Project	IEEE 802.16 Broadband Wireless Access Working Group < http://ieee802.org/16 >	
Title	Short Initial ranging Transmission for IEEE 802.16 OFDMA	
Date Submitted	2003-09-11	
Source(s)	Hyoungsoo Lim Dong Seung Kwon ETRI 161 Gajeong-Dong, Yuseong-Gu Daejeon, Korea	Voice: +82-42-860-1608 Fax: +82-42-860-6732 mailto:lim@etri.re.kr
Re:	Task Group Review of IEEE 802.16e-03/07r3	
Abstract	This contribution is to propose a modification to the length of the initial ranging transmission for IEEE 802.16 OFDMA.	
Purpose	Task group approval of the modification.	
Notice	This document has been prepared to assist IEEE 802.16. It is offered as a basis for discussion and is not binding on the contributing individual(s) or organization(s). The material in this document is subject to change in form and content after further study. The contributor(s) reserve(s) the right to add, amend or withdraw material contained herein.

Short Initial ranging Transmission for IEEE 802.16 OFDMA

Figure 1—Initial ranging transmission for IEEE 802.16 OFDMA in the current draft

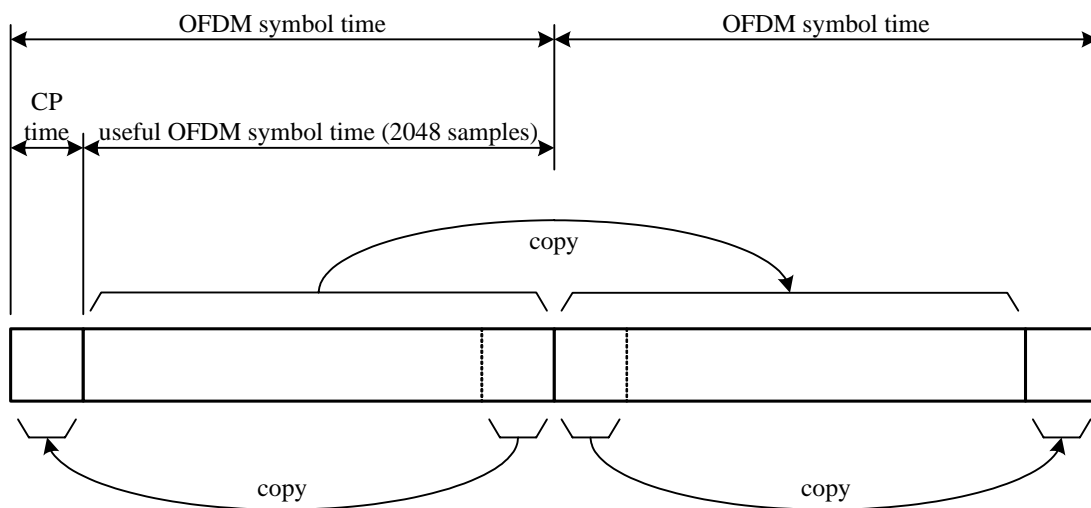
Arrival timings of initial ranging signals at a BS are not subject to be aligned with the OFDM symbol timing at the BS. The only information each SS under initial ranging has is the received downlink OFDM symbol timing, which the initial ranging signal is to be aligned with. Therefore, the initial ranging signals from the SS's close to the BS arrive at the BS with little timing offset while the initial ranging signals from the outermost SS's on the cell boundary arrive at the BS with a timing offset equal to the round trip delay. The current draft specifies the initial ranging transmission to last two OFDM symbol times by repeating itself without phase discontinuity as shown in Figure 1 in order to guarantee a full continuous-phase signal over the intended OFDM symbol epoch¹ for successful detection and timing offset estimation of the received initial ranging transmission.

Figure 3–Example of successive initial ranging transmissions adjacent in time

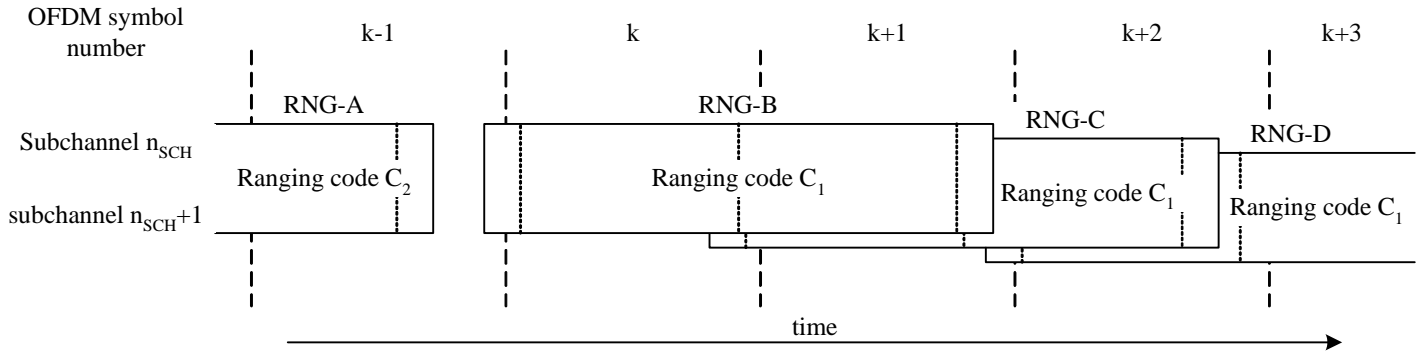
Let us consider the example in Figure 3, where three different SS's initiate initial ranging at three successive OFDM symbol epochs with an identical ranging code. Ideally, all three initial ranging transmissions should be successfully detected since the SS's have chosen three different epochs. However, with the current design of initial ranging transmission, the incomplete portions of RNG-B and RNG-C in the $(k+1)$ st and $(k+2)$ nd OFDM symbol epochs degrade the detection of RNG-C and RNG-D, respectively.

Figure 4–Proposed initial ranging transmission for OFDMA

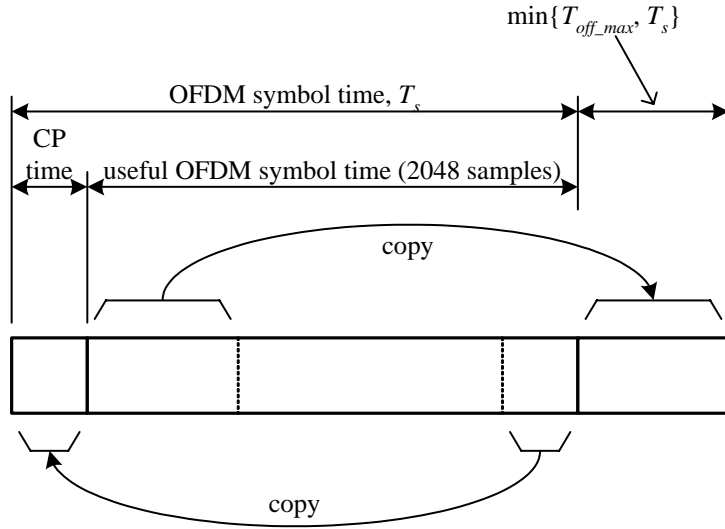
Unlike the preceding portion of the RNG-B in the $(k-1)$ st OFDM symbol epoch, the portion of RNG-B in the $(k+1)$ st OFDM symbol epoch can be shortened to reduce the interference to other uplink transmissions. In order to guarantee a complete continuous-phase signal during the intended OFDM symbol epoch at the BS, the length of the initial ranging transmission has only to be $T_s + T_{off_max}$, where T_s denotes the OFDM symbol time and T_{off_max} is not smaller than the maximum round trip delay between the BS and an SS within the cell. The length of the initial ranging transmission is limited to $2T_s$. Figure 4 shows the proposed initial ranging transmission for OFDMA. This short initial ranging transmission scheme also reduces the amount of resources required for initial ranging by half, which is another important advantage. Reversely speaking, this also means that employing the proposed short initial ranging transmission doubles the number of detectable initial ranging transmissions.

We can consider three means to inform all the SS's in a cell of the value of T_{off_max} : First, we can define another TLV encoded DCD channel information on T_{off_max} ; Second, T_{off_max} can be replaced with TTG since TTG is larger than the maximum round trip delay of the cell; Third, we can define another format of Initial Ranging Information Element in UL-MAP to deliver information on T_{off_max} .

Figure 128bca–Proposed initial ranging transmission for OFDMA

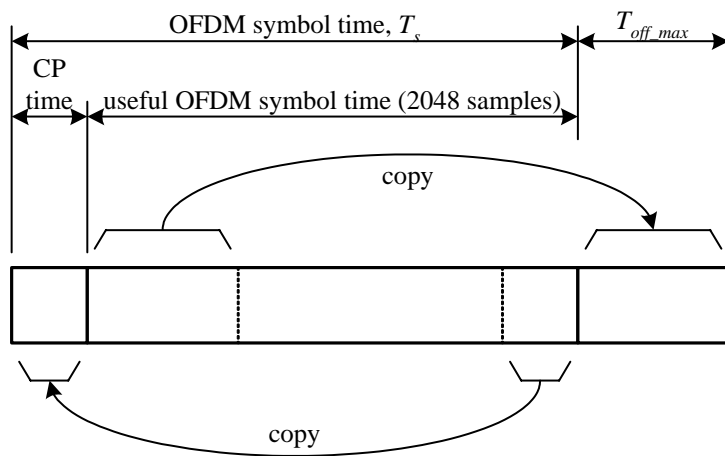
Replace Figure 128bc with the following:

and delete the second and the third sentences in 8.5.7.1 as follows:

The initial_ranging transmission shall be used by any SS that wants to synchronize to the system channel for the first time. ~~An initial ranging transmission shall be performed during two consecutive symbols. The same ranging code is transmitted on the ranging channel during each symbol.~~ A time-domain illustration of the initial_ranging transmission is shown in Figure 128bca.

Figure 128bcb–Proposed initial ranging transmission for OFDMA

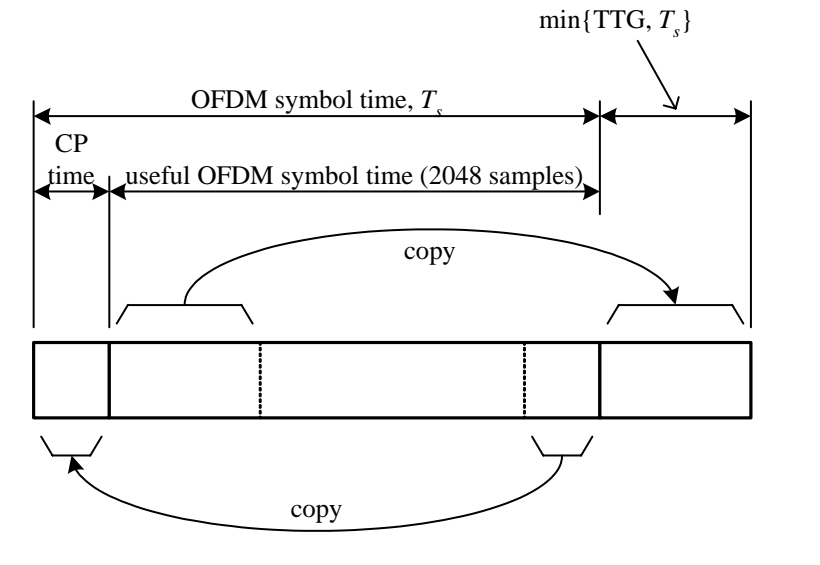
Replace Figure 128bc with the following:

and delete the second and the third sentences in 8.5.7.1 as follows:

The initial_ranging transmission shall be used by any SS that wants to synchronize to the system channel for the first time. ~~An initial ranging transmission shall be performed during two consecutive symbols. The same ranging code is transmitted on the ranging channel during each symbol.~~ A time-domain illustration of the initial_ranging transmission is shown in Figure 128bcb.
